**SUBDIVISION,
PLANNED UNIT DEVELOPMENT &
PLANNING APPROVAL STAFF REPORT****Date: June 2, 2016**

<u>NAME</u>	Word of God Church
<u>SUBDIVISION NAME</u>	Word of God Church Subdivision
<u>LOCATION</u>	6455 & 6459 Overlook Road (South side of Overlook Road, at the South terminus of Godwin Lane).
<u>CITY COUNCIL DISTRICT</u>	District 7
<u>PRESENT ZONING</u>	R-1, Single Family District
<u>AREA OF PROPERTY</u>	3.3± Acre
<u>CONTEMPLATED USE</u>	Subdivision approval to create one legal lot of record; Planned Unit Development to allow multiple buildings on a single building site with shared access and parking; and, Planning Approval to allow the expansion of an existing church in an R-1, Single Family Residential District.
<u>TIME SCHEDULE FOR DEVELOPMENT</u>	Not Specified
<u>ENGINEERING COMMENTS</u>

PROPOSED SITE PLAN - PHASE 3

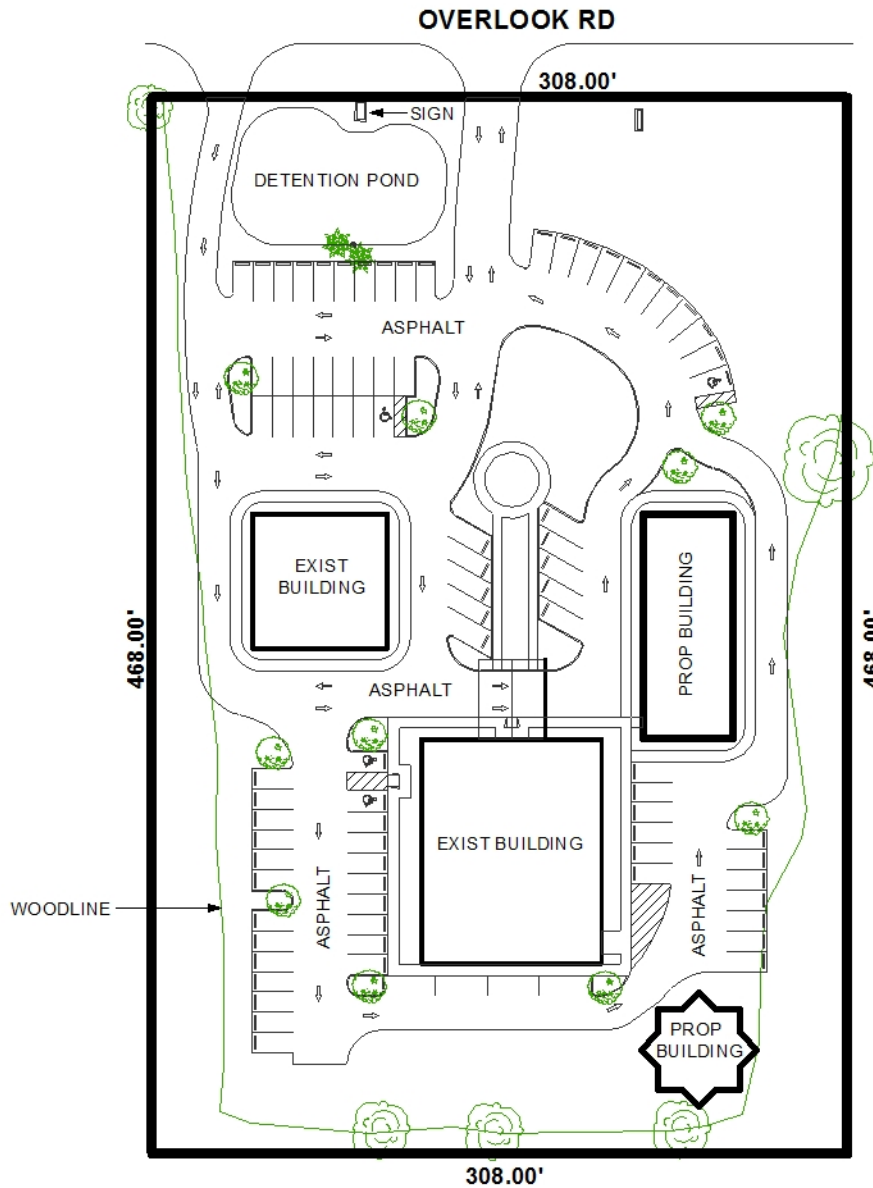
residential properties. It should be noted that one of the proposed structures extends into the 25' setback illustrated at the rear of the site, but the structure appears to comply with the required 10' setback.

- 6) *Revision of the site plan to indicate the proposed use of each building on the site;*
- 7) *Revision of the site plan to show all structures located outside of the property setbacks;*
